TORRANCE TRANSIT REGIONAL PARK & RIDE TERMINAL

DESIGN GUIDELINES & STANDARDS

OCTOBER 10, 2012

The Torrance Transit Park & Ride Regional Terminal Guidelines and Standards report documents the results of the 3 week design review process involving City staff and the RNL team. This report is organized by topic, beginning with building architecture, then canopy, and finally site development. During this process, the project design was developed considerably further than the existing 30% design, which will necessarily require modification to the existing 30% package. However, to reiterate,

Figure 1.4 Partition terminations need an eloquent solution.

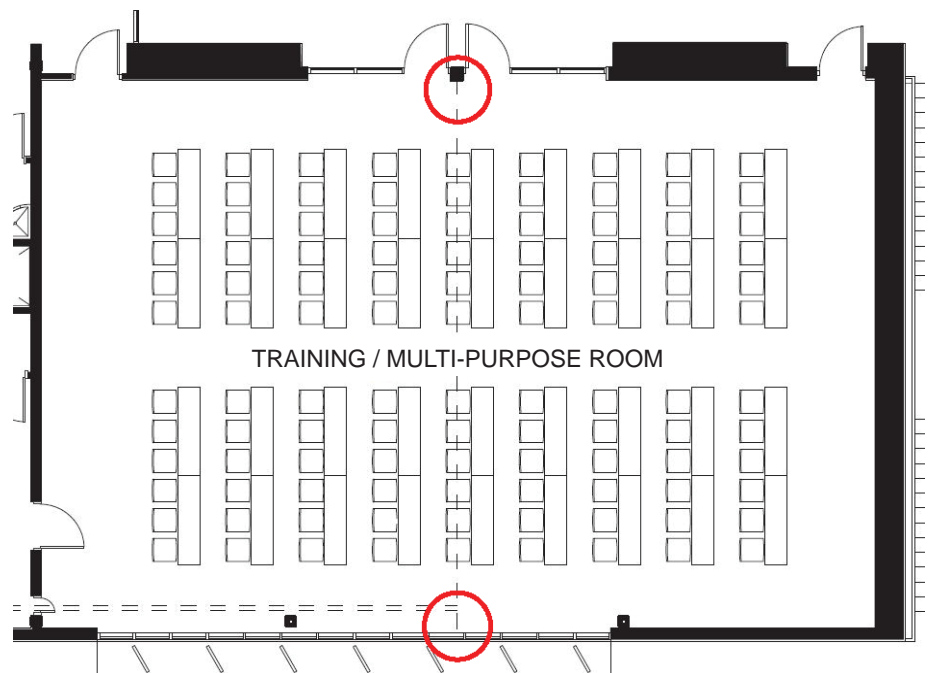
- Develop operable partition end closure conditions that will be functional and blend in with the architecture. (Figure 1.4).
- Provide robust stacking chairs and folding training tables that will be stored within the connecting storage room.

Figure 1.5 Commercial space #107 may be subdivided and a second service door added to the south wall.

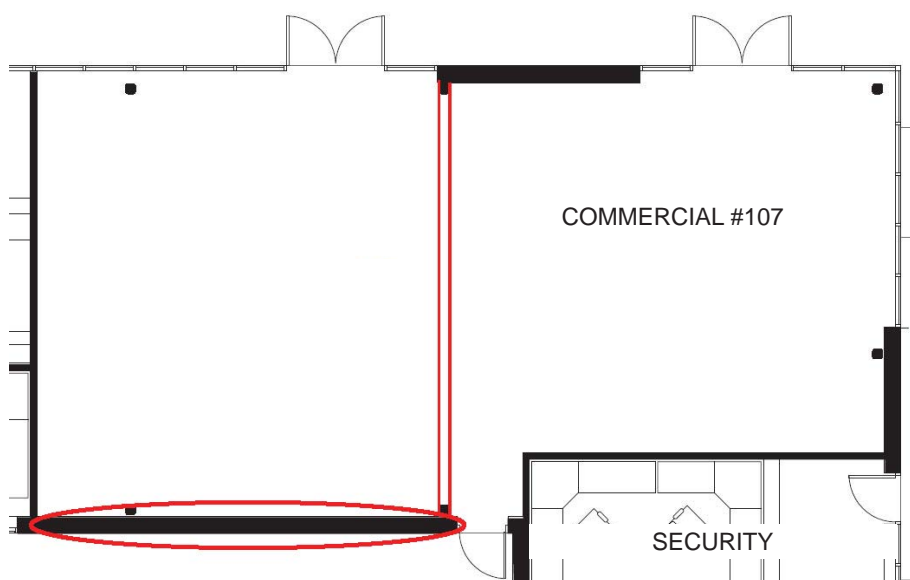
- Upon securing commercial tenants, West Building commercial space #107 may be subdivided by constructing a partition wall running north-south located just west of the supplied service door and that a second service door opening should be framed out so at some time in the future, the opening could be knocked out and a door installed to access the west space. (Figure 1.5).

A102

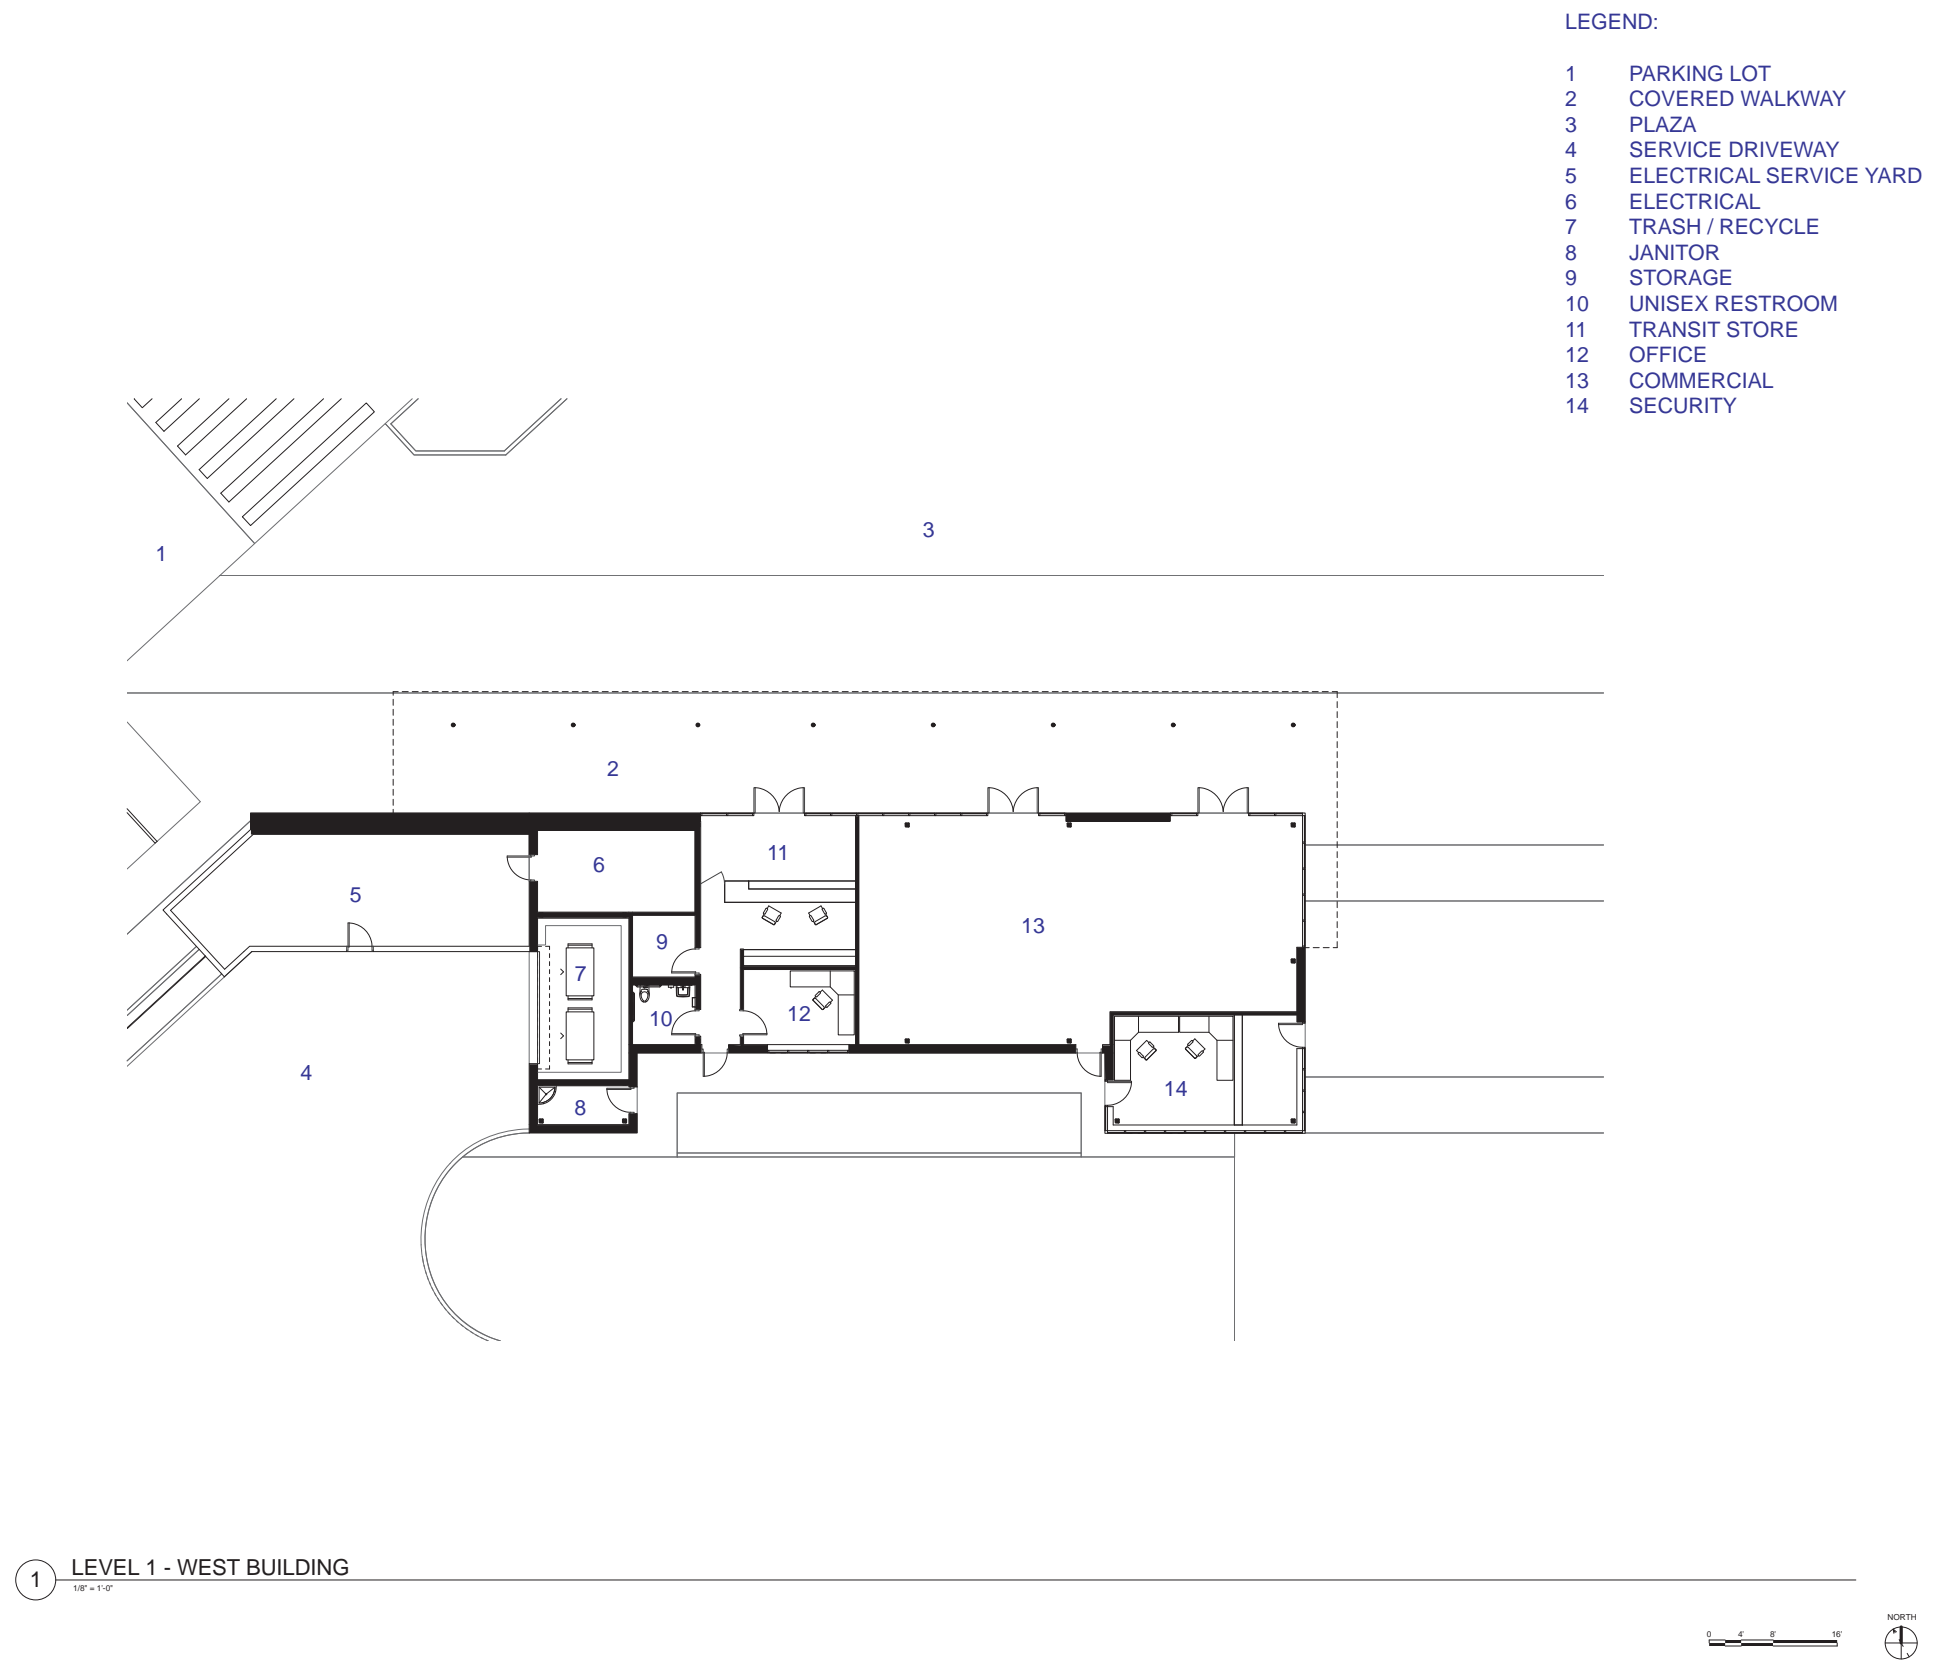
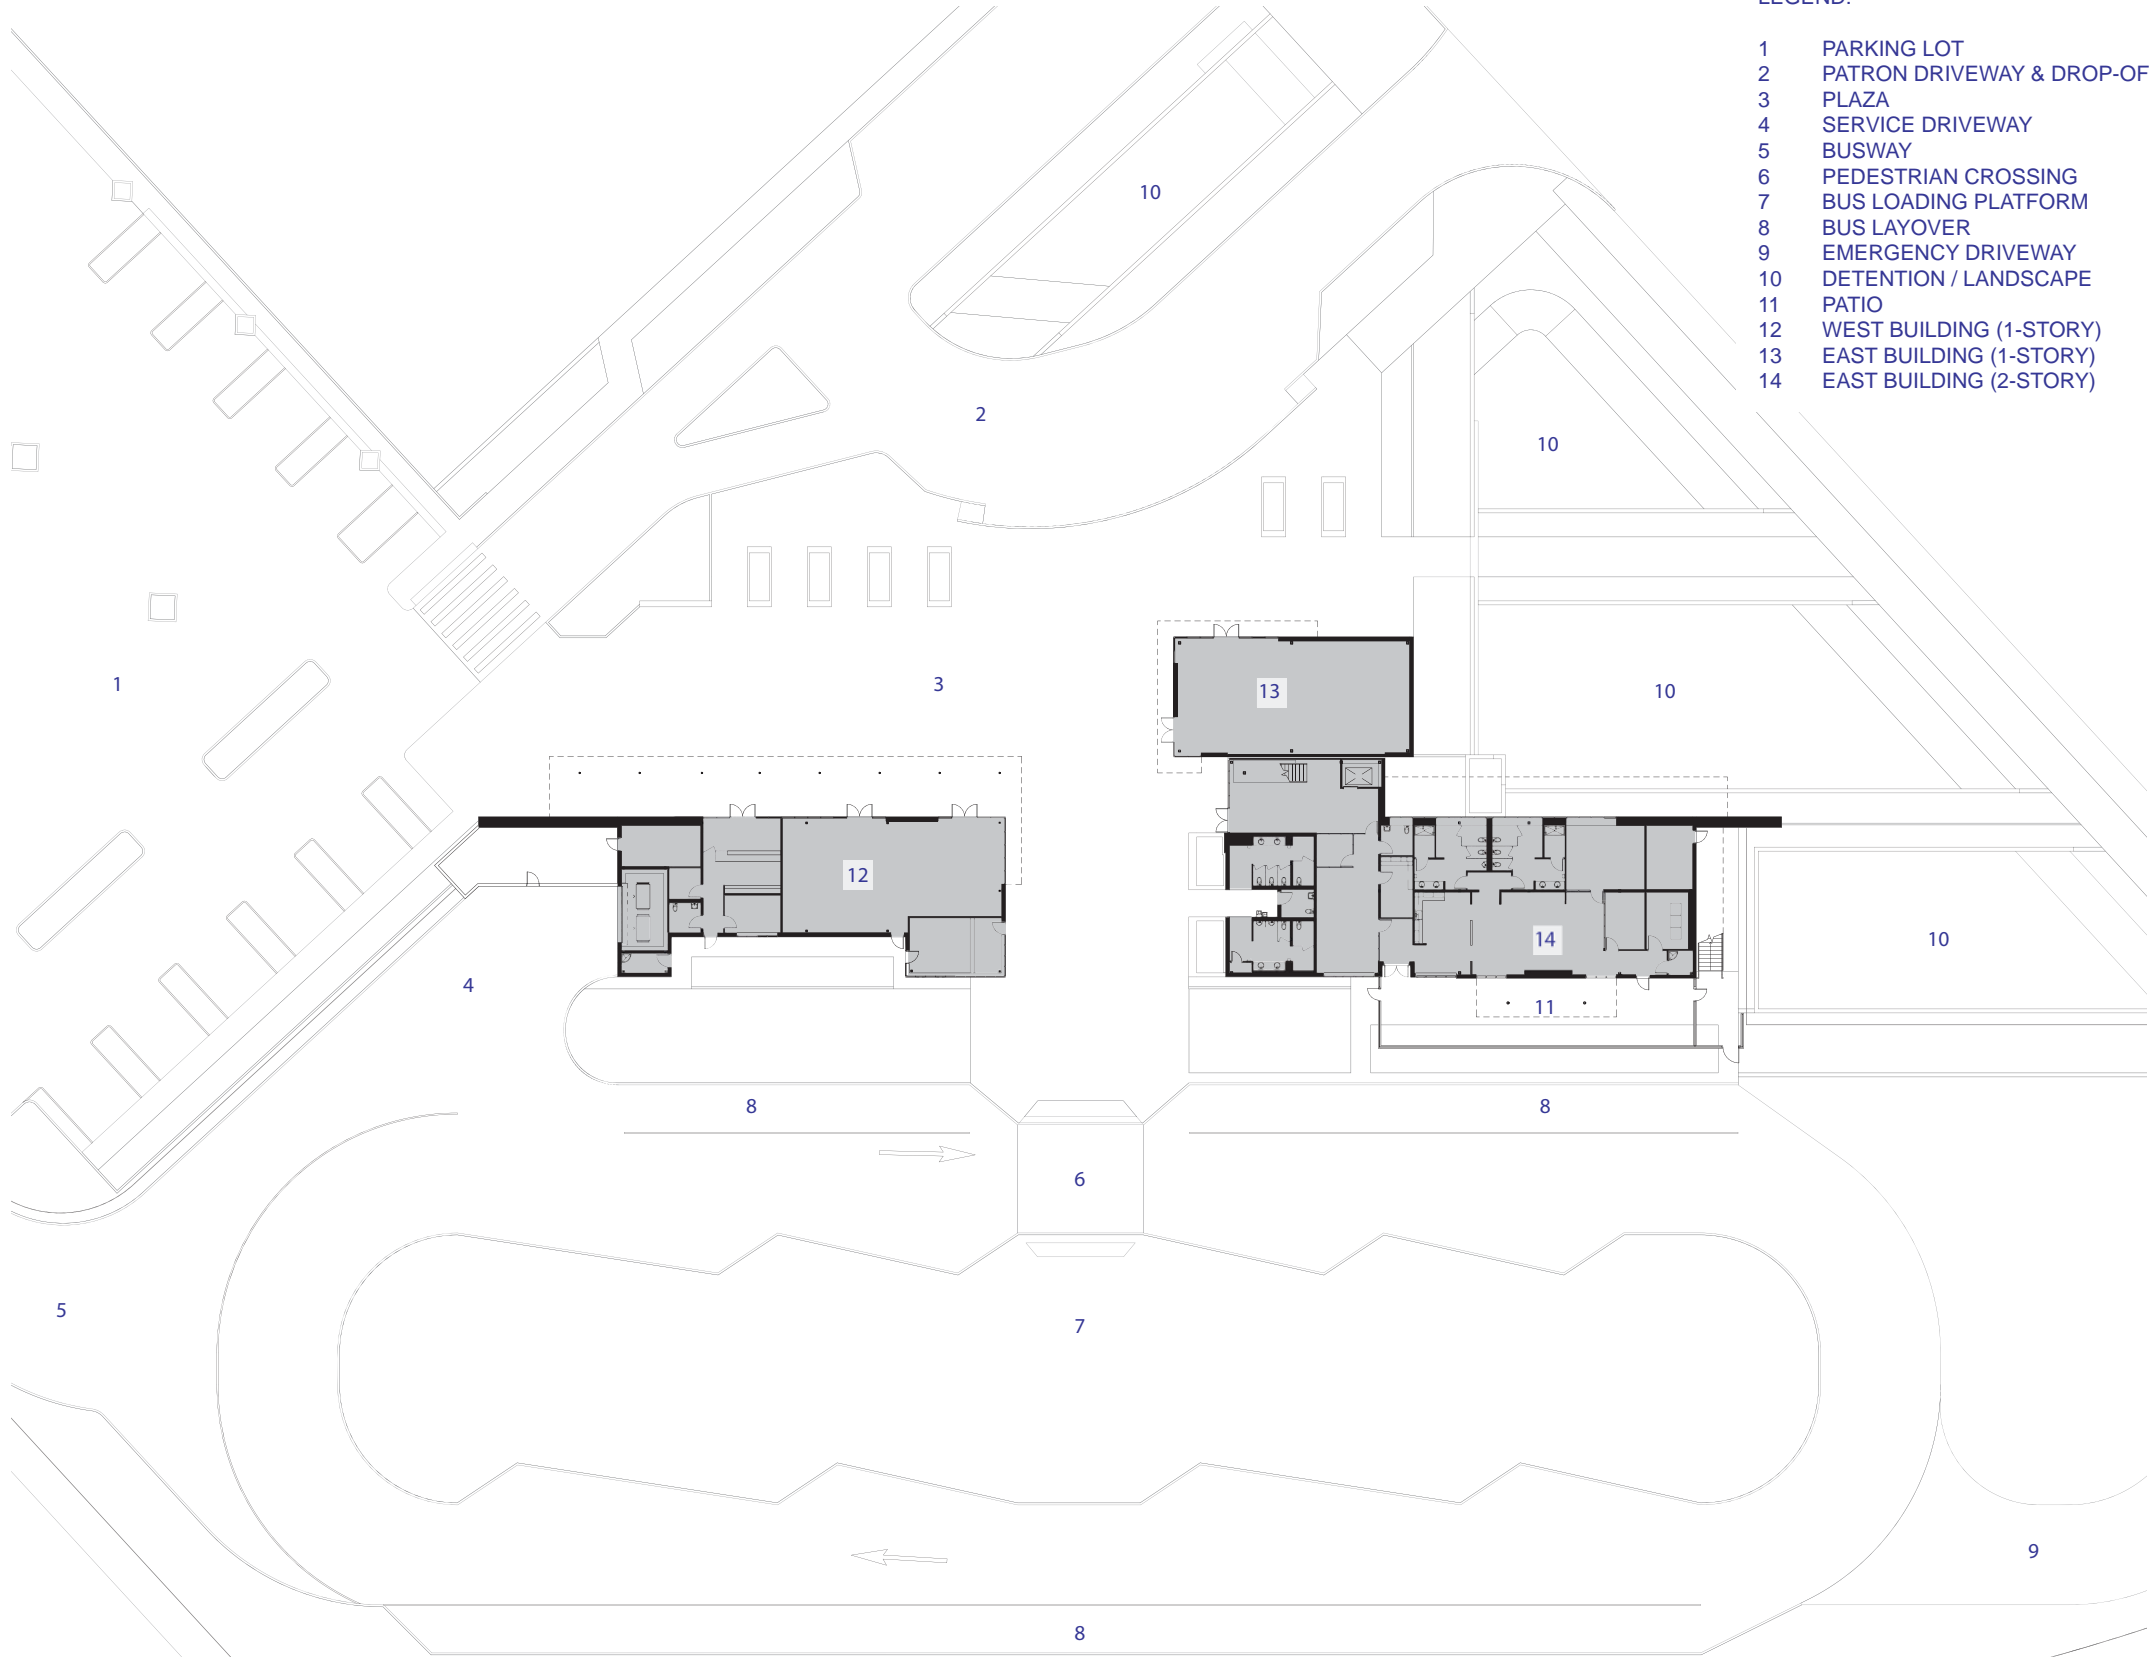
Generally, the building floor plans as presented in 30% design were accepted. Minor adjustments and further development of the interiors are required during the future project phase. Sheet A102 shows the enlarged Transit Center site.

A110

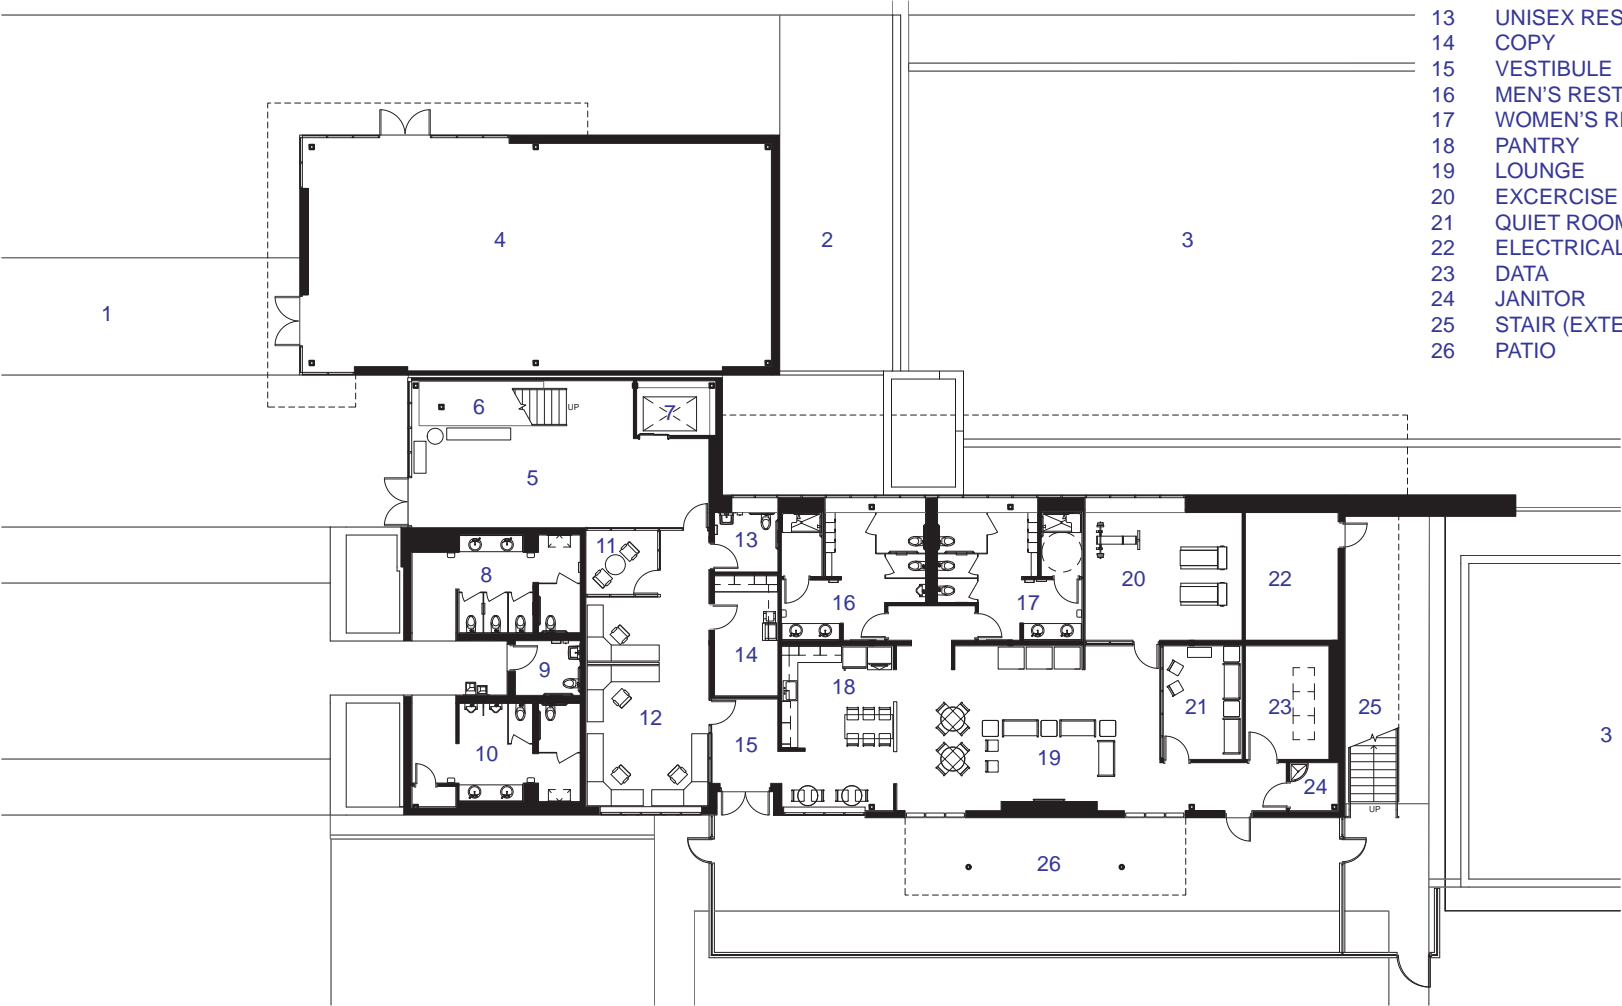
The building floor plan was generally accepted as presented in the 30% documents. See sheet A110.

- Develop floor tile patterns within the Transit Store.
- Study the interior design of the counters and shelving within the Transit Store and Security Office.
- Provide further office amenities such as storage consoles, workstations and white boards within the Transit Store Office.
- Provide storage amenities within the Storage Room.

Figure 2.47 Awning modification diagram.

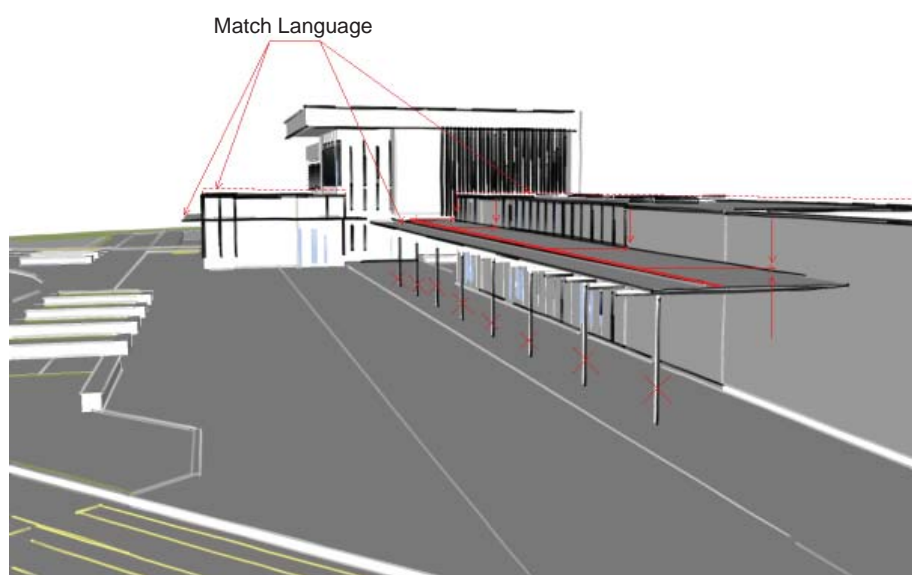
Visible in the 3D 30% design model and the drawings are the pedestrian level canopies that are connected to the buildings, here called awnings. Three awning locations exist, at the: Operator's Patio for rain and sun protection and interior sun protection; at the Commercial space #106 for minimal rain protection at the doors and interior sun protection; and at the north and east sides of the West Building to create a covered walkway. The City's team expressed their concern that the amount of columns within the plaza, which includes the freestanding canopy and awning columns, is too great, limiting the plaza's usability, flexibility and creating more pedestrian obstacles than necessary.

- Reduce the dimensions of the West Building awning in the plaza to an acceptable comfortable walking width while eliminating the row of West Building awning posts to and provide awning support from the building. (Figure 2.47).
- Study raising the West Building and East Building commercial space parapets to accommodate awning structural support while maintaining the overall current massing of the buildings.
